ADDENDUM # 01

Blue Ridge Community College

One Stop - Renovation Phase II

SCO ID# 18-18892-01A

G-101

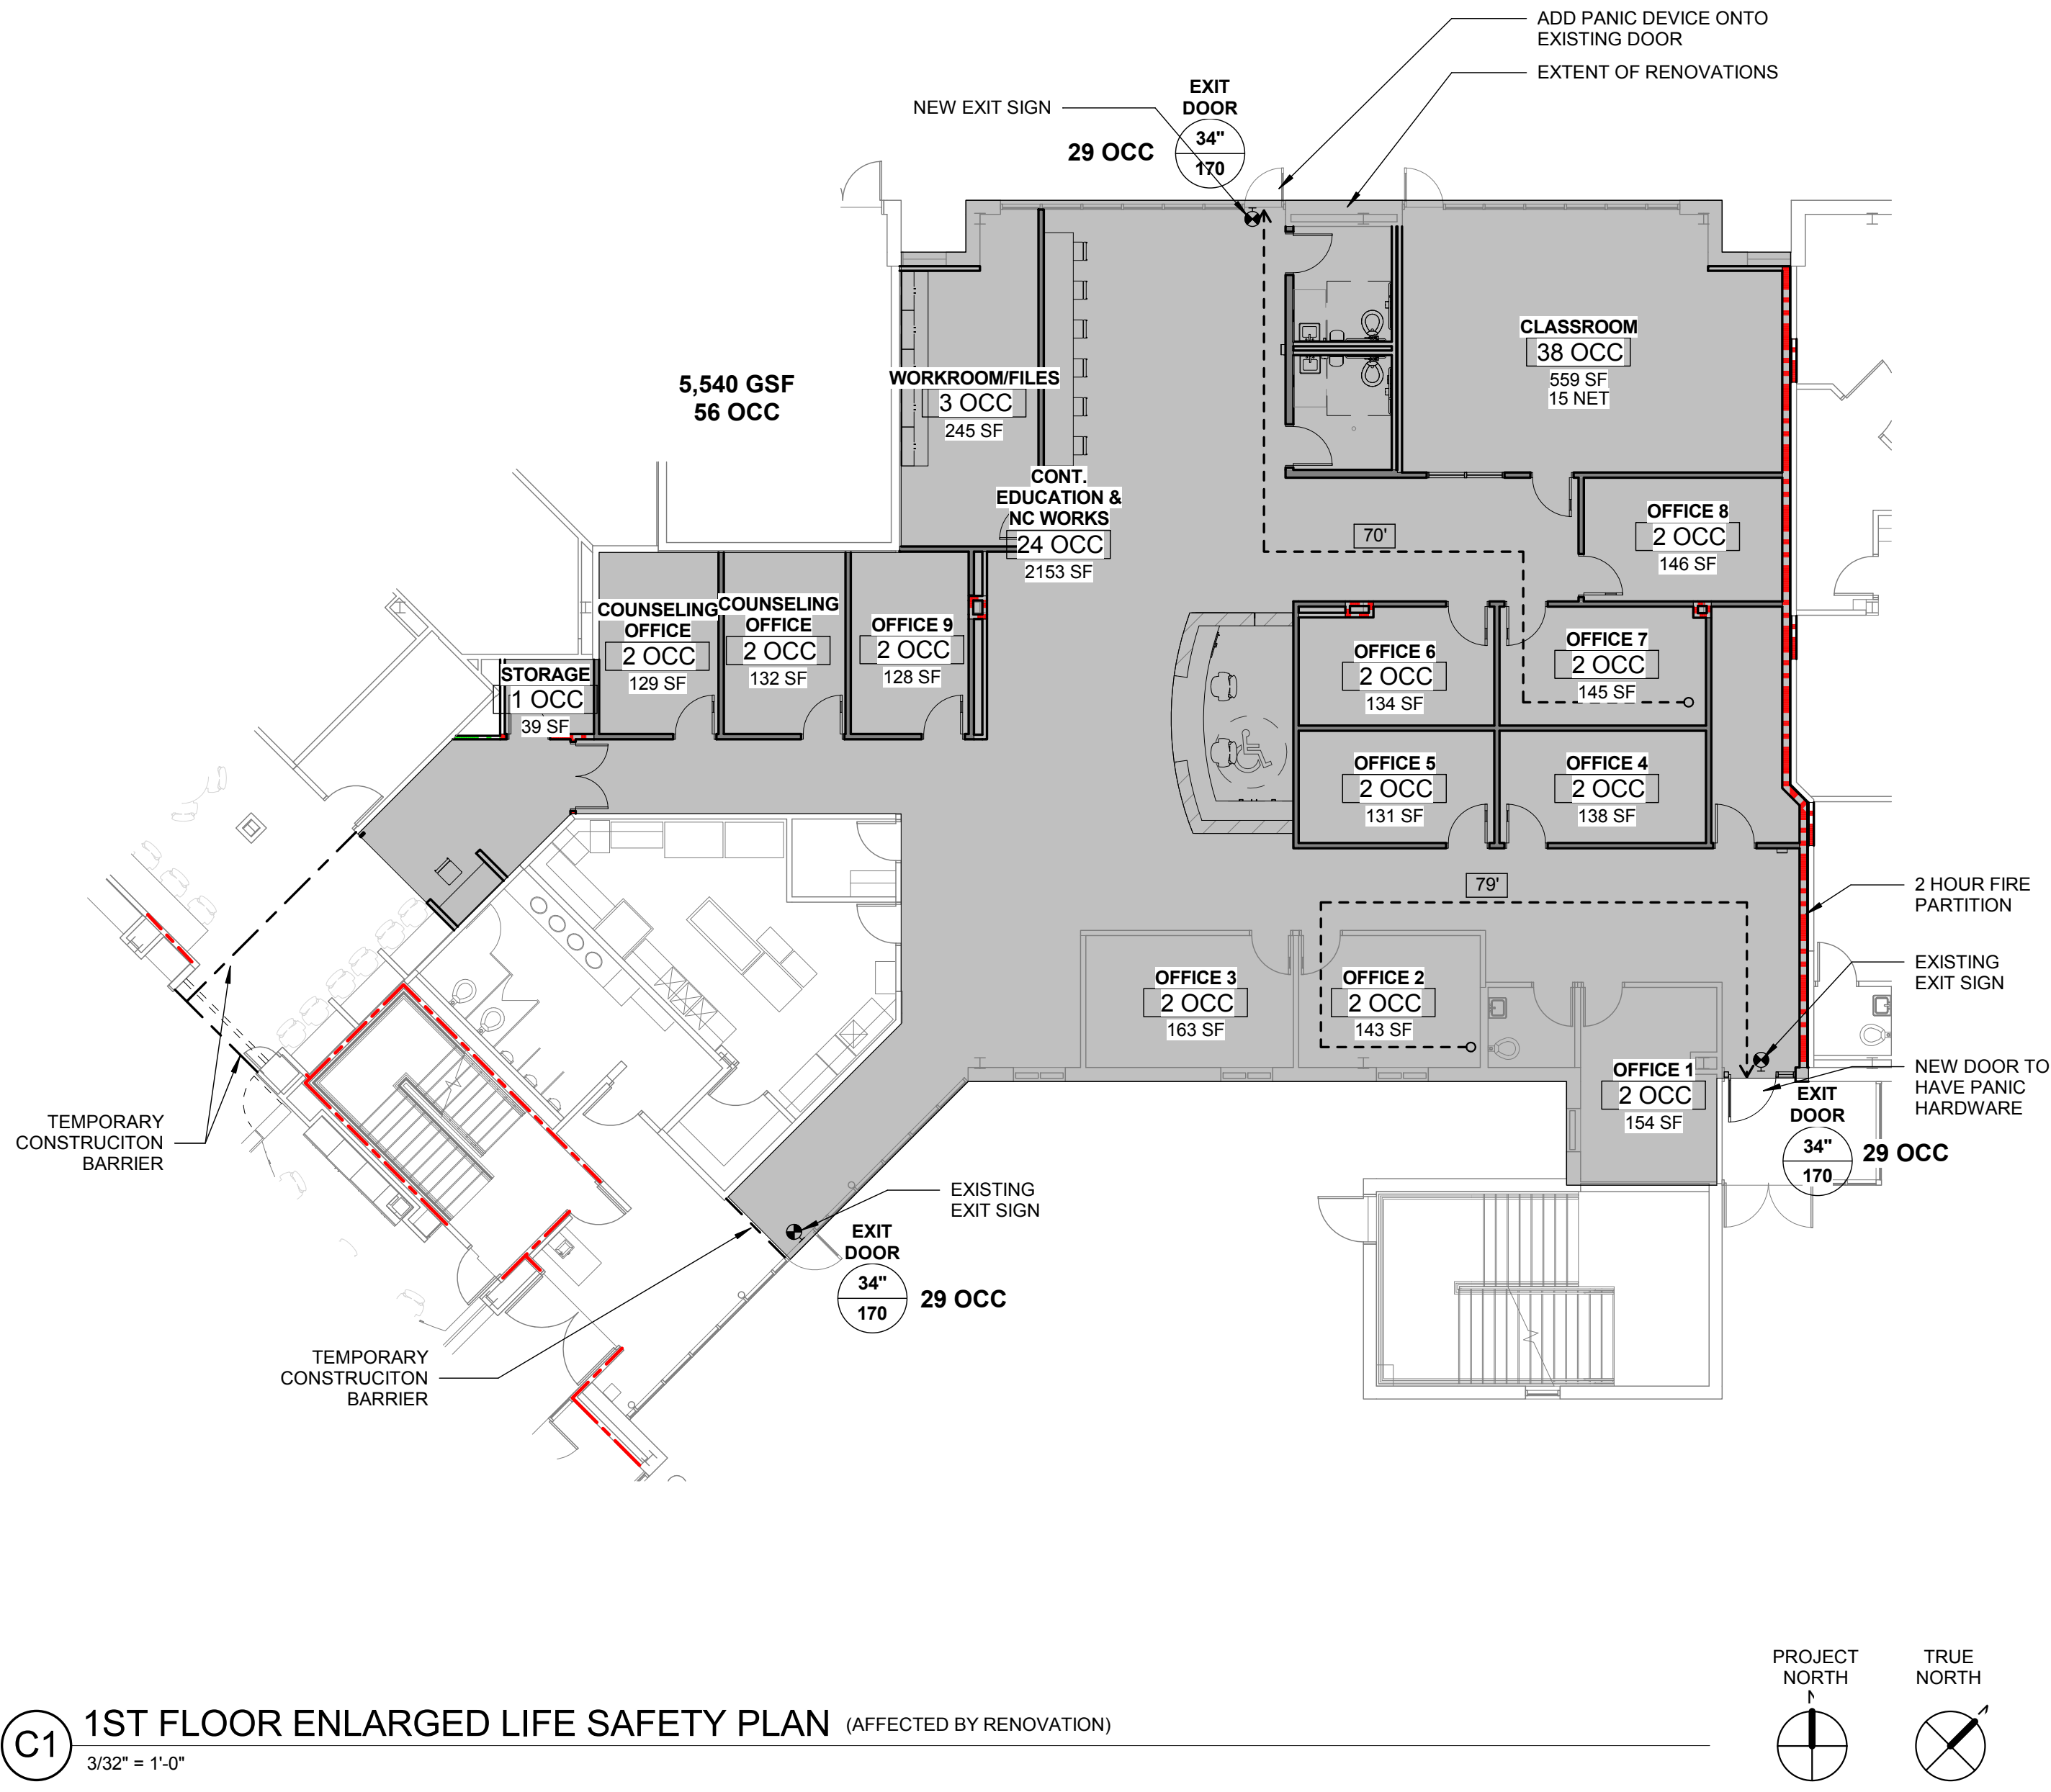
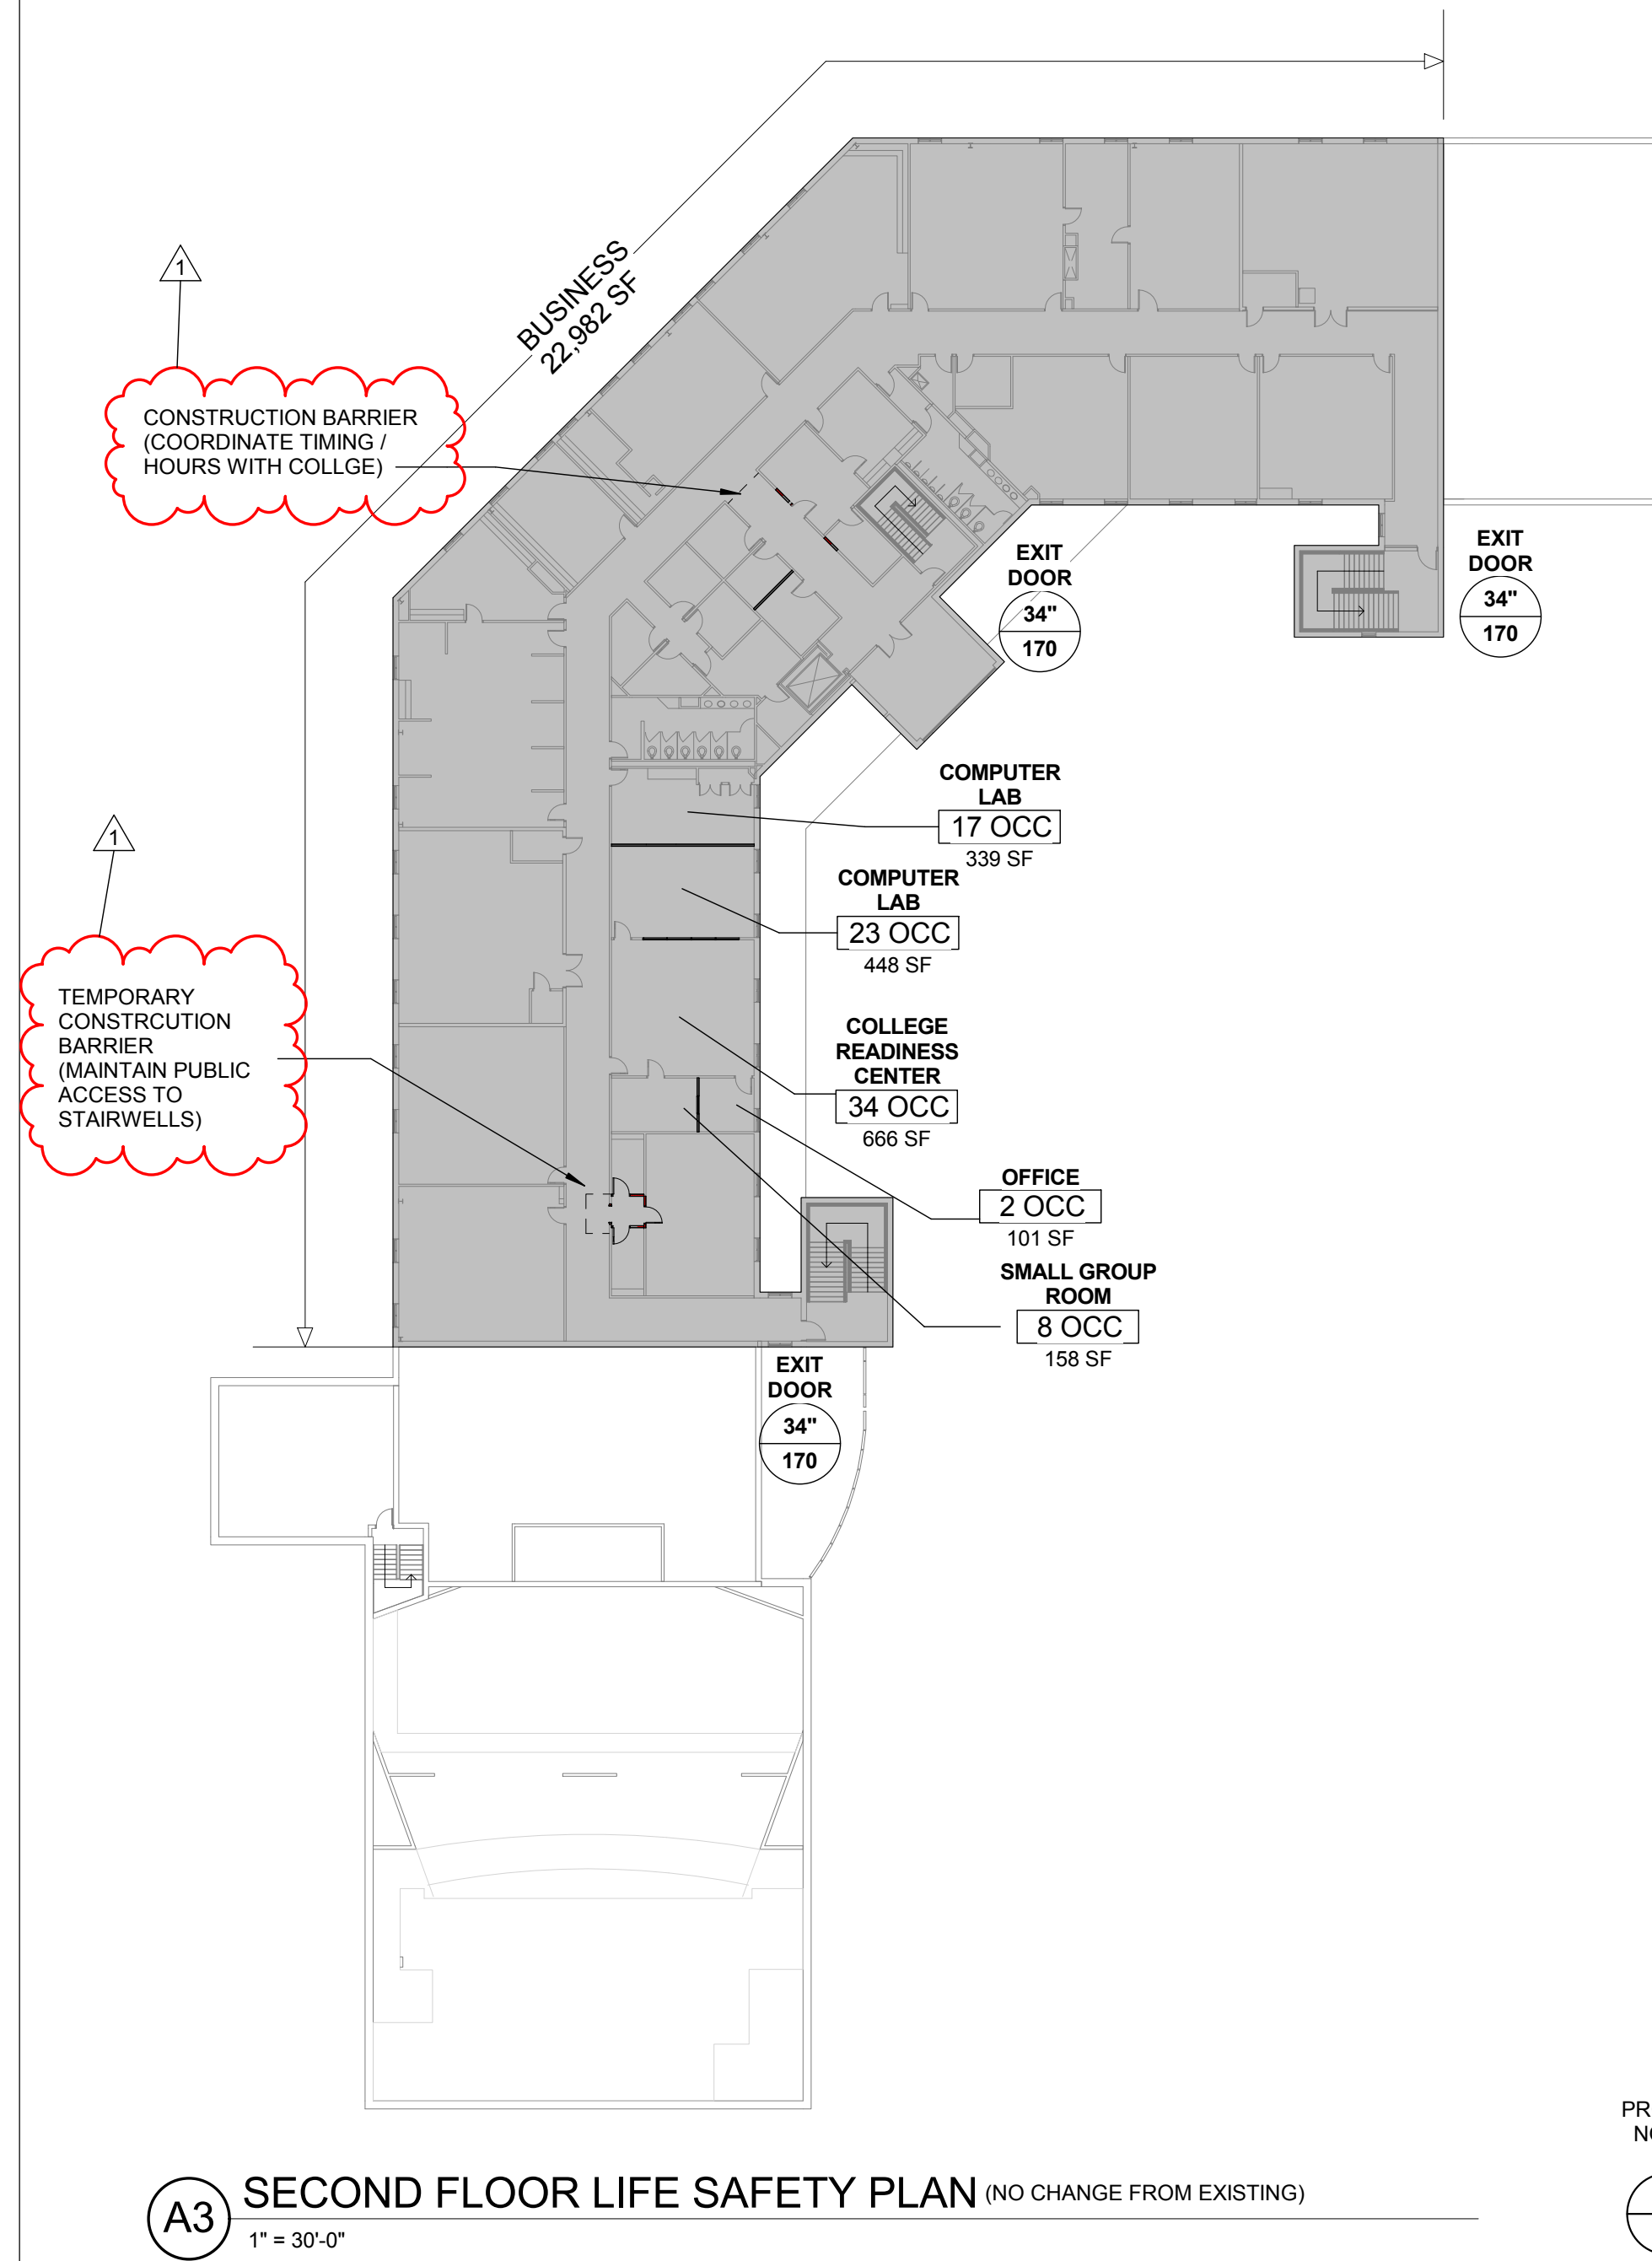
- 3.1 G-101 – LIFE SAFETY PLANS: Updated temporary barrier information.
- 3.2 A-002 – PARTITION TYPES: Updated partition type for walls at restrooms to extend to deck.
- 3.3 A-101 – FIRST FLOOR PLAN: Provided clarity for renovated components, wall types.
- 3.4 A-401 - ENLARGED PLANS: Updated restroom accessories information
- 3.5 A-601 – DOOR SCHEDULE, DOOR TYPE LEGEND & FRAME TYPES: Updated door information.
